Firmware Release Note

2 Version of updated firmware : R1515

3 Updated contents to R1515 from R1510

A) Disk information dialog

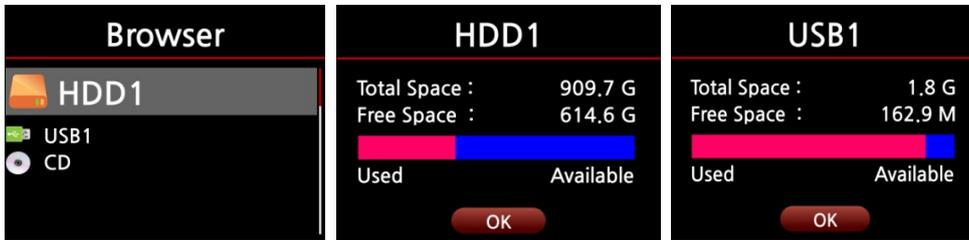
We changed disk information dialog like below.

B) Showing track number and actual title for ripping CD by the unit of track.

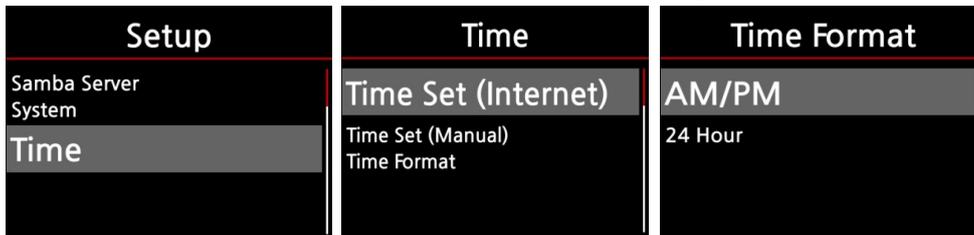
When you rip CD by the unit of track, dialog window shows track number and actual title in case that the CD information is in the FreeDB database.

D) Function to get information on Ripping result and converting result

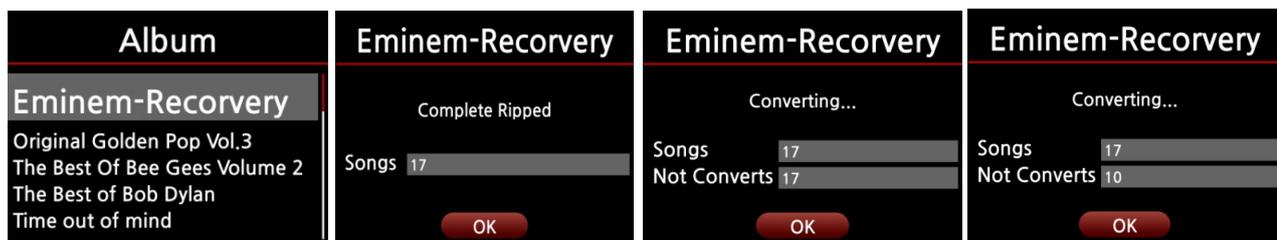
Place cursor on the Album in the Music DB and press INFO button of remote control.

You can see the result of ripping and converting like below picture.

F) External storage function.

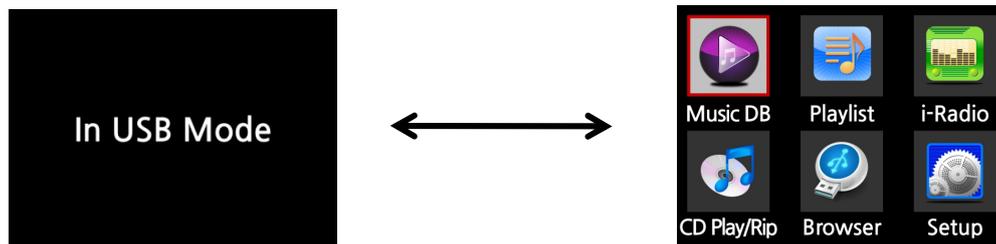
When you connect X10 to computer with USB cable, the screen of X10 shows 'In USB Mode'. Remote control does not work in this mode. If you disconnect X10 from PC with safety removal, X10 will return to normal mode within 3~5 seconds.

H) Title mode in Music DB was added.

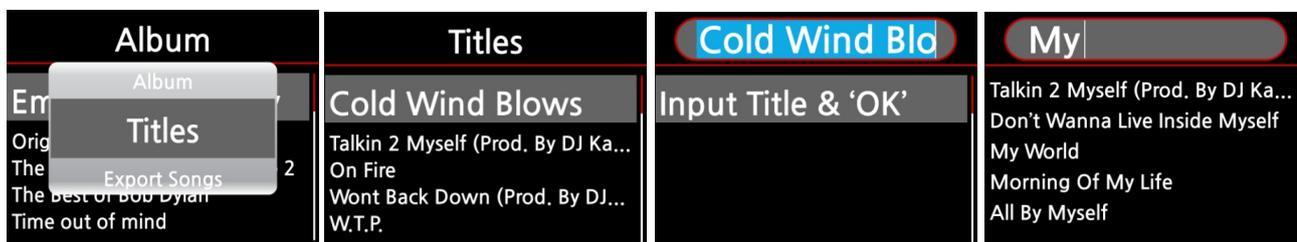
You can do filtering by the title and run Search function by the title like below.
